South Texas Project Electric Generating Station 4000 Avenue F - Suite A Bay City, Texas 77414

August 12, 2008  
ABR-AE-08000061

South Texas Project  
Units 3 and 4  
Docket Nos. 52-012 and 52-013  
Response to Requests for Additional Information

Attached are responses to NRC staff questions included in Request for Additional Information (RAI) letter numbers 31, 34, 39, 40, 49, 50 and 52 related to Combined License Application (COLA) Part 2, Tier 2 Sections 2.4S and 2.5S. This submittal includes responses to the following Question numbers:

Figure 1 – HEC-HMS Hydrologic Diagram for Scenario 1

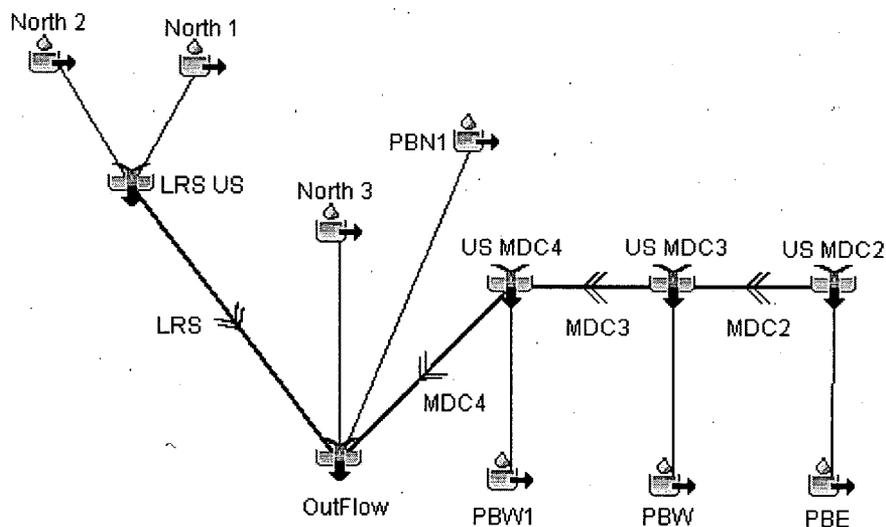
Provide a discussion of (A) flood magnitude and timing; (B) the effect on water levels in the power block area; and, (C) the effect of the 34 ft MSL constant water level boundary condition in HEC-RAS simulation, if FM 521 were not to act like a barrier and flood runoff from North 1 and 2 subbasins were not lagged significantly. Provide justification for using a 6-hr PMP, rather than using a shorter duration and more intense PMP value, to obtain a peak PMF water level in the power block area. Specify in the FSAR, at which spot within the power block area, the peak flooding level was simulated.

In Scenario 1, flood flow from North1 and North2 is assumed to discharge to LRS unimpeded. This is accomplished in the HEC-HMS flood routing model (Reference 1) by assigning a junction element, instead of a reservoir element as in the COLA base case, at the FM 521 crossing at LRS. The conceptual model for Scenario 1 as represented in HEC-HMS is shown on

Figure 1, while the scheme for the COLA base case presented in the FSAR is shown on Figure 2.4S.2-6 of Revision 0 of the FSAR.

The HEC-HMS results for Scenario 1 show that the peak discharge from the northern subbasins (North1 and North2) that contributes to LRS (9,714.9 cfs) is higher and arrives earlier (5:25 hrs into the storm) than the peak discharge (7,690.3 cfs) and arrival time (6:25 hrs into the storm) from the COLA base case. For Scenario 1, the predicted peak discharge at model junction Outflow is 11,459.6 cfs, which is about 16% higher than the peak discharge of 9852.0 cfs from the COLA base case simulation. The arrival times of the peaks are nearly the same, 3:35 hrs and 3:40 hrs into the storm, respectively. The peak discharges and their arrival times at the subbasin outlets for the eastern subbasins (PBE, PBW, PBN1 and PBW1) remain unchanged. The predicted peak discharges and the corresponding flood peak arrival time for each subbasin are shown in Table 1. A time step of 5 min is used in the HEC-HMS model simulation.

Figure 3 – Precipitation Distribution and Resulting Runoff for Subbasin PBN1

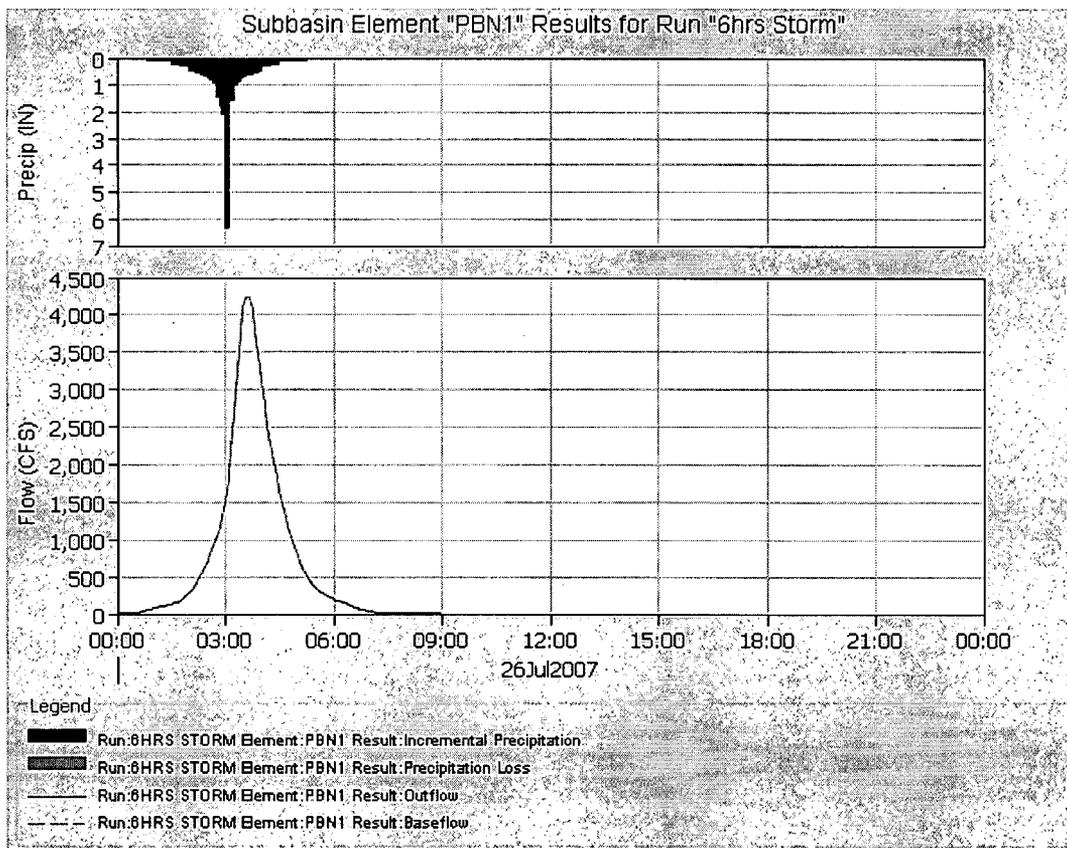
RAI Part 2: Provide justification for using a 6-hr PMP, rather than using a shorter duration and more intense PMP value, to obtain a peak PMF water level in the power block area.

The 6-hr PMP storm used as input to the HEC-HMS flood model is represented by PMP rainfall depths of 5 min, 15 min, 1 hr, 2 hrs, 3 hrs and 6 hrs durations as shown in Table 2.4S.2-4 of Revision 0 of FSAR. The effect of the more intense PMP values corresponding to shorter duration events, down to a 5-minute duration, on the water level in the power block area have been captured in the HEC-HMS and HEC-RAS analyses. Figure 3, which shows the distribution of precipitation intensities and resulting runoff hydrograph for the subbasin PBN1, is provided as an example.

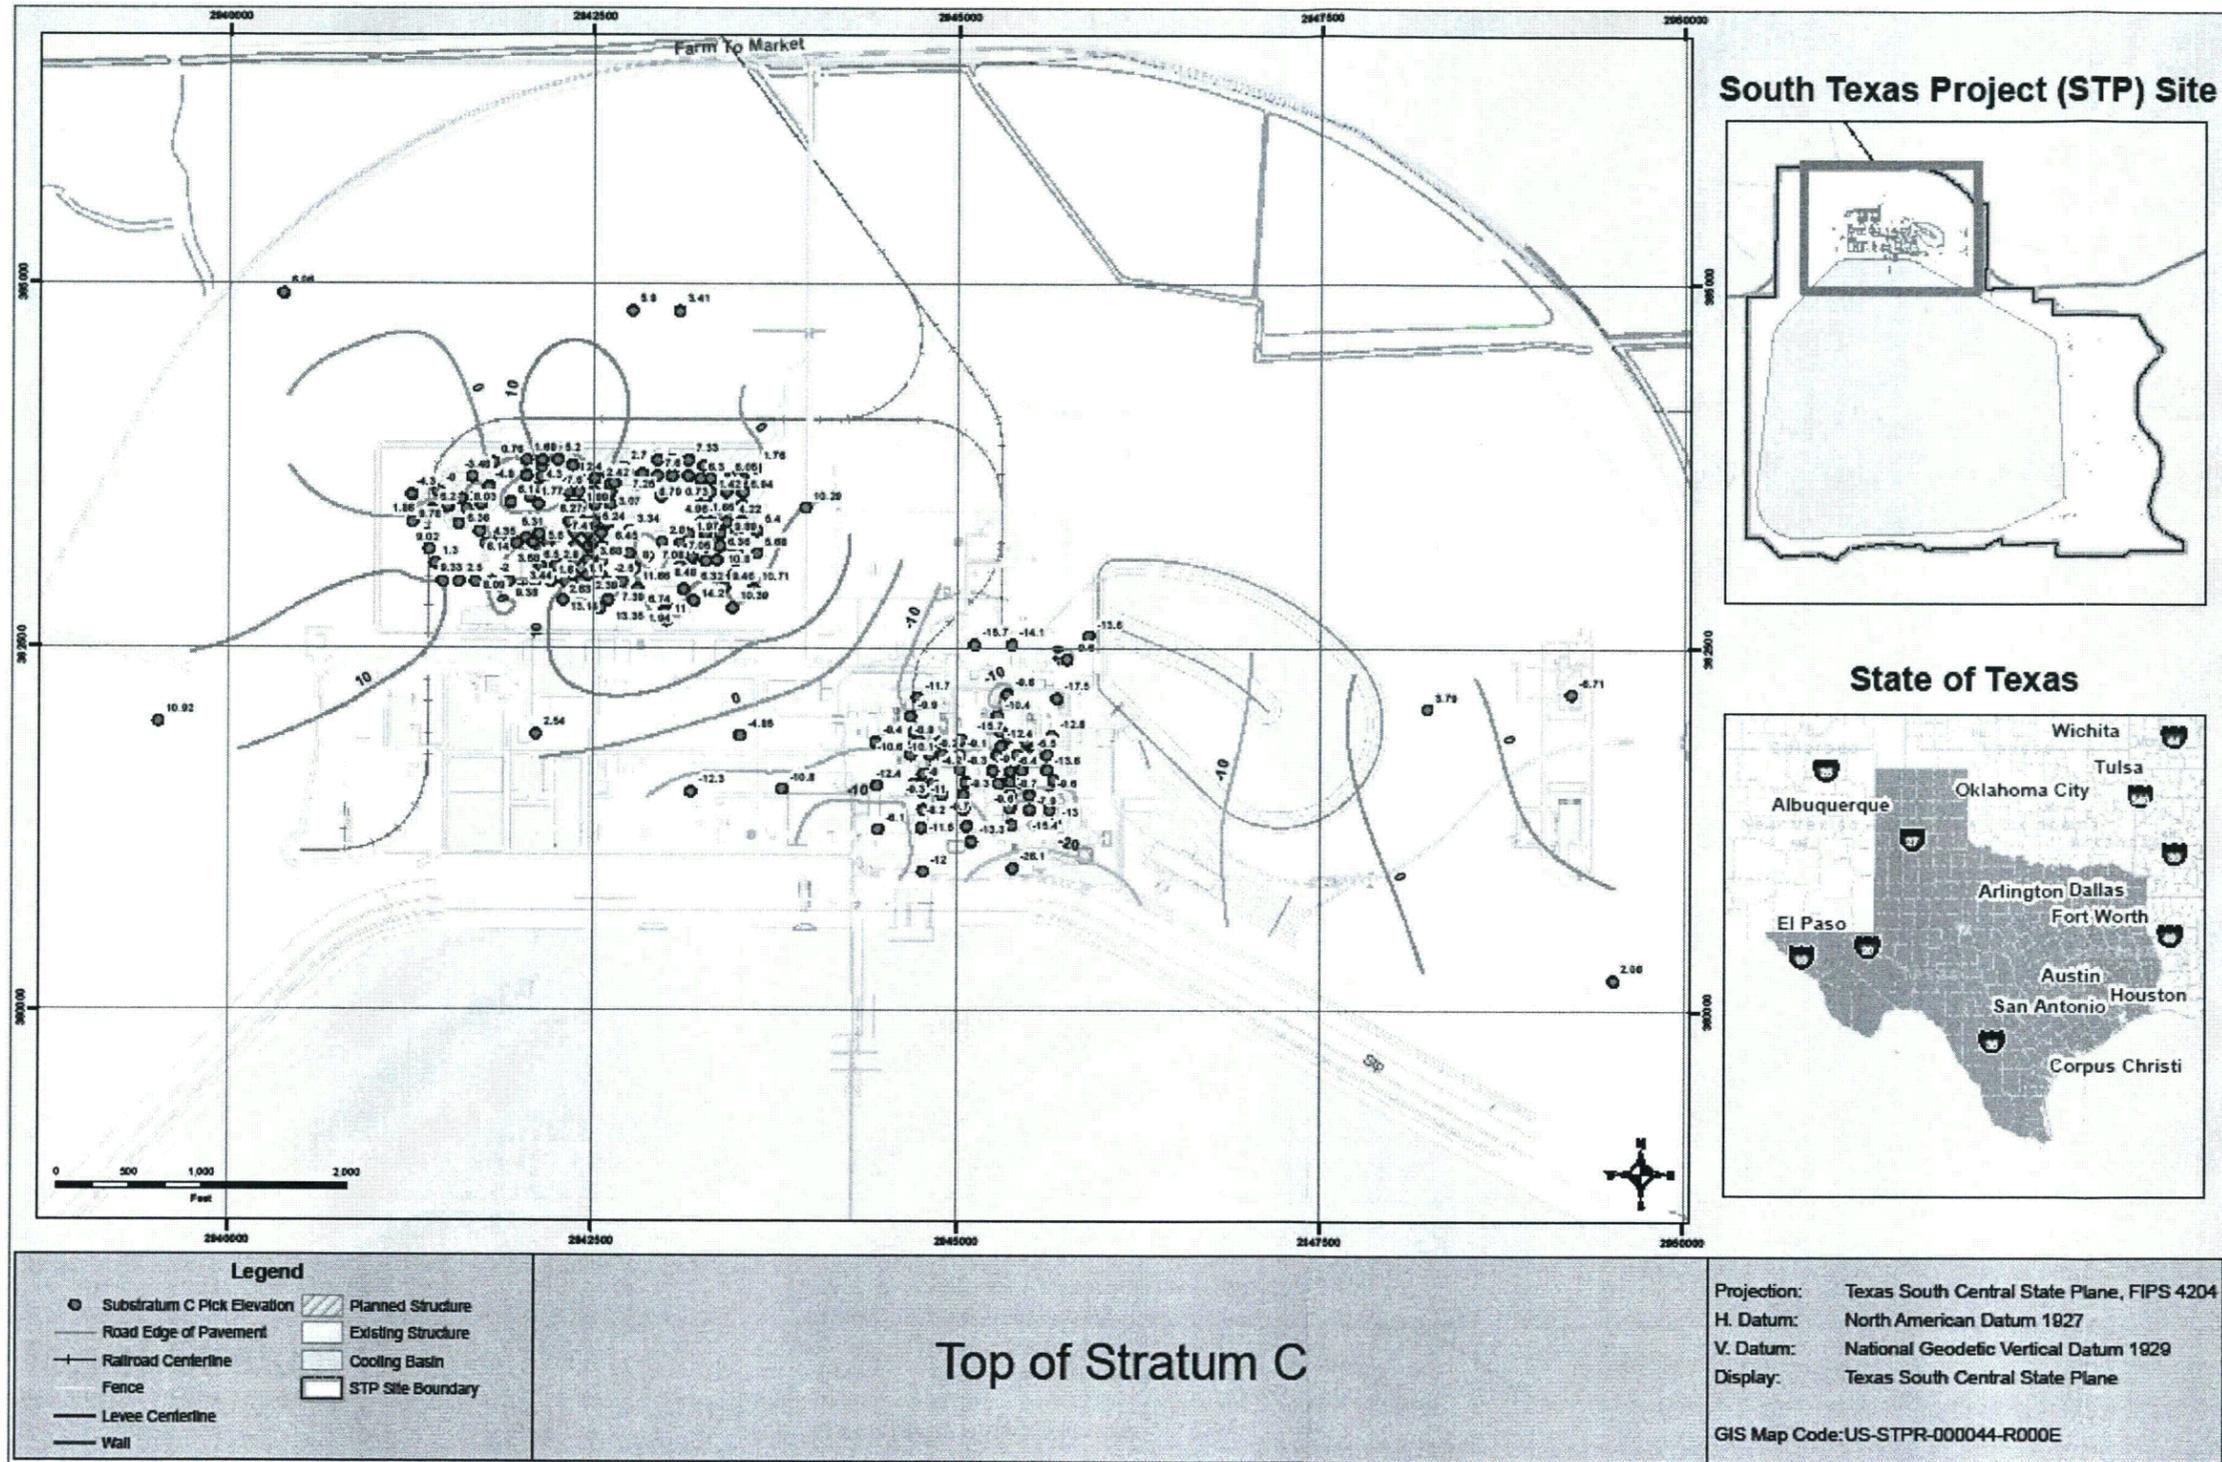
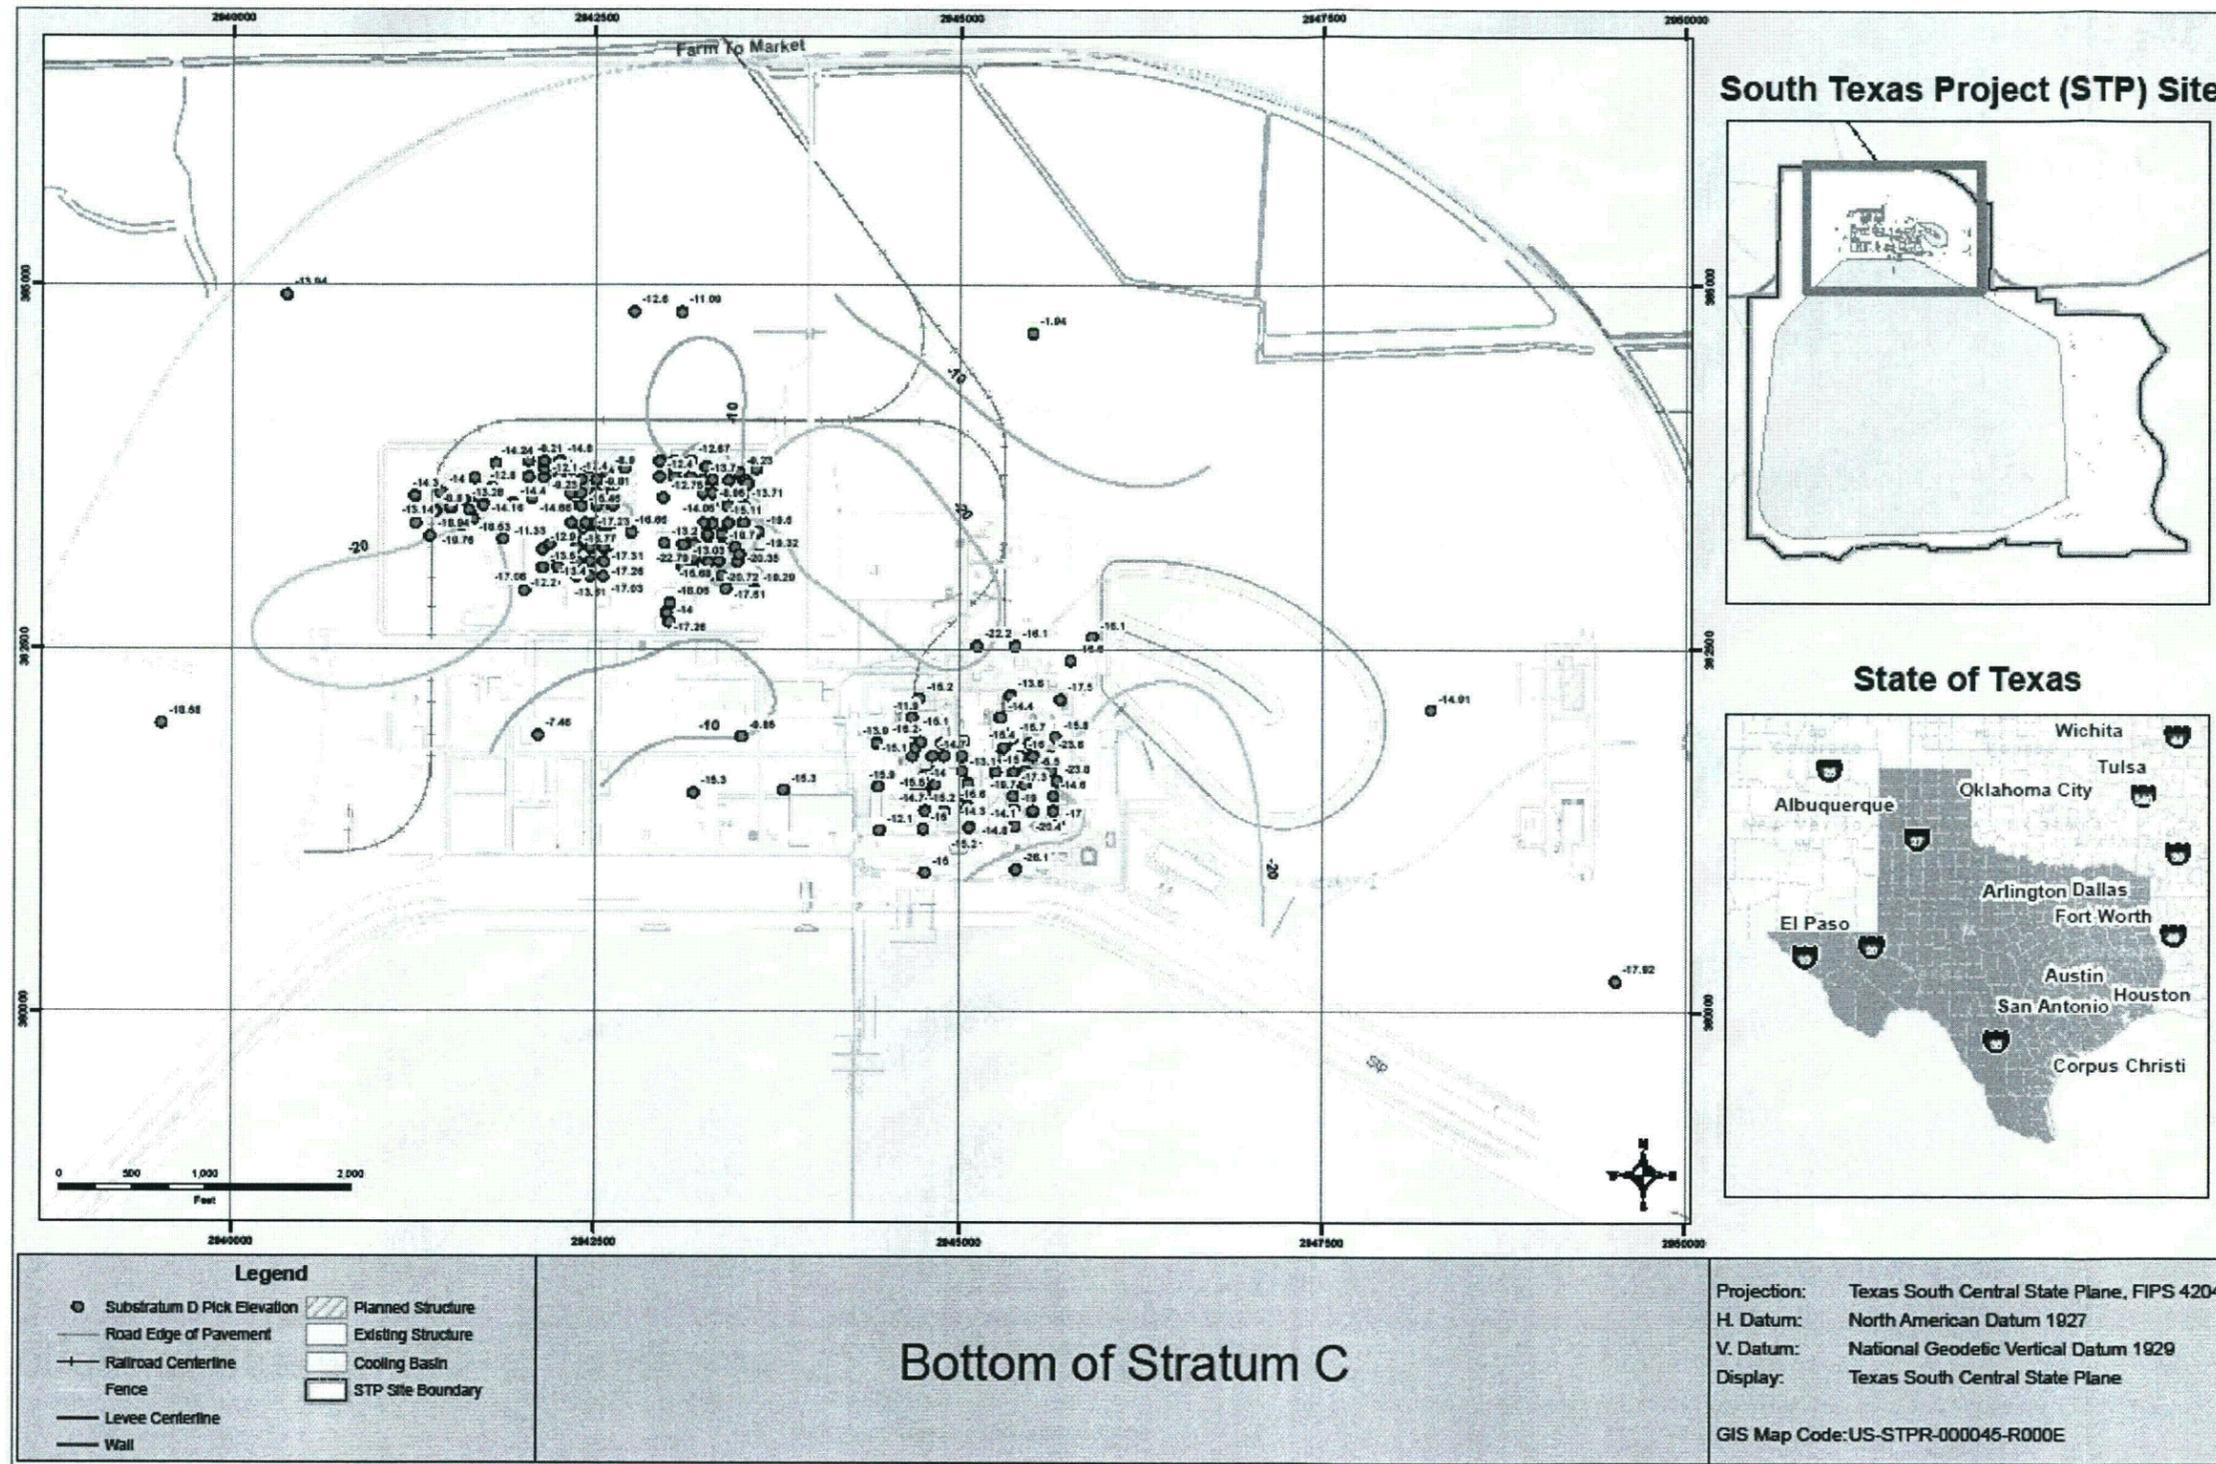
Provide detailed surface maps for top and bottom elevations of both Upper and Lower Shallow Aquifers as they are needed to better understand and predict on-site groundwater flow and pathways. Figure 2.4S.12-10 shows many piezometric wells around Units 1 and 2, but it is not clear whether the water level data from all the wells were used for the water level contour maps in Figure 2.4S.12-19. Please clarify.

The requested maps are attached. The maps are a geostatistical interpretation of available data representing the top and bottom elevations of the Upper Shallow Aquifer (Geotechnical Stratum C from FSAR 2.5S.4) and Lower Shallow Aquifer (Geotechnical Strata E and H from FSAR 2.5S.4). The tension-spline method in ESRI ArcGIS software was used to contour the available data. The data are from the Units 1 & 2 UFSAR (reference) and the STP Units 3 & 4 geotechnical evaluation.

The Lower Shallow Aquifer includes two sand units (Geotechnical Strata E and H) separated in places by a discontinuous clay unit (Geotechnical Stratum F from FSAR 2.5S.4). Where encountered in borings, this clay unit has been observed with a thickness that can range from about 0.7 feet to about 61.5 feet with an average of about 20 feet. However, the encountered thickness at most borings is between about 10 to 30 feet. (It should be noted several borings did not fully penetrate the unit.)

The water level contour maps in Figure 2.4S.12-19 used the data from the observation wells drilled during the 2006 - 2007 subsurface investigation for Units 3 & 4 (the "Units 3 & 4 wells"), because this was the only relevant data available for the two dates represented in that figure. The other piezometers shown in Figure 2.4S.12-10 were installed more than 20 years ago. Most of these piezometers no longer exist or relevant construction details are no longer available. The most recent data available from these piezometers are from May 1, 2006. The earliest data available for the "Units 3 & 4 wells" are from December 28, 2006 (Table 2.4S.12-7). These two data sets are not contemporaneous and, as a result, cannot be combined to prepare contour maps such as those in Figure 2.4S.12-19. Plans are underway to install additional observation wells at the STP site to obtain hydrogeologic information in the vicinity of Kelly Lake and to reduce the uncertainty associated with the groundwater flow paths near the MCR and site boundary.
